Product Change Notification

Change Notification #: 113785 - 00
Change Title: Intel® Server System R1304BB4GS9
PCN 113785-00, Product Design, Label
Add a Mylar and Plastic Block and update
the Safety label with an EAC logo instead of a
GOST logo
Date of Publication: April 16, 2015

Figure-1: Pre-Change

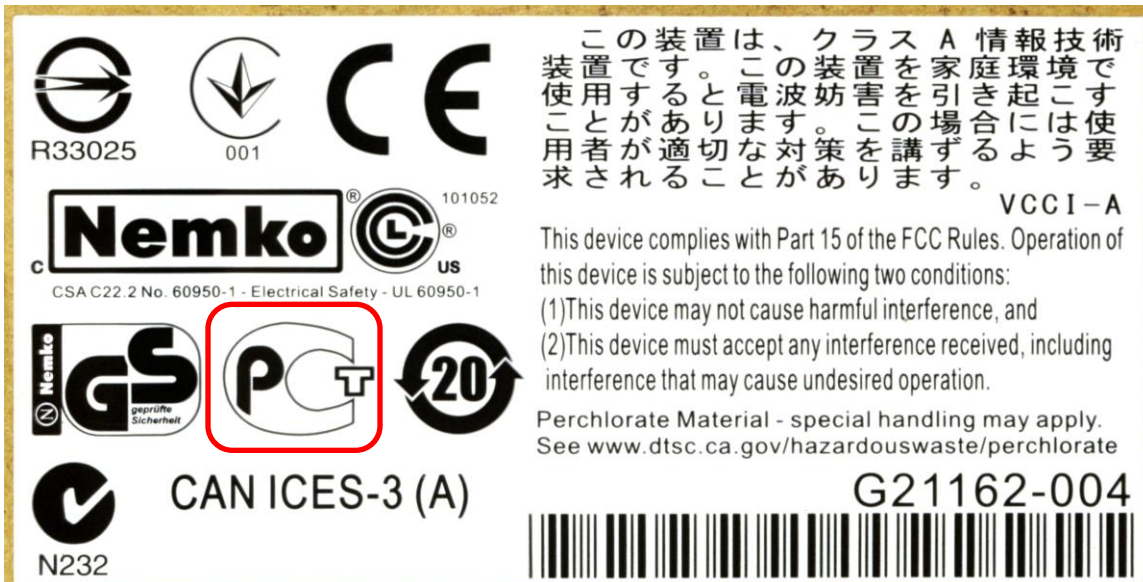
2. Update the Safety Label: Put an EAC logo instead of a GOST logo for certification update. Please see Figure-1 and Figure-2 below for details.

Figure-2: Post-Change
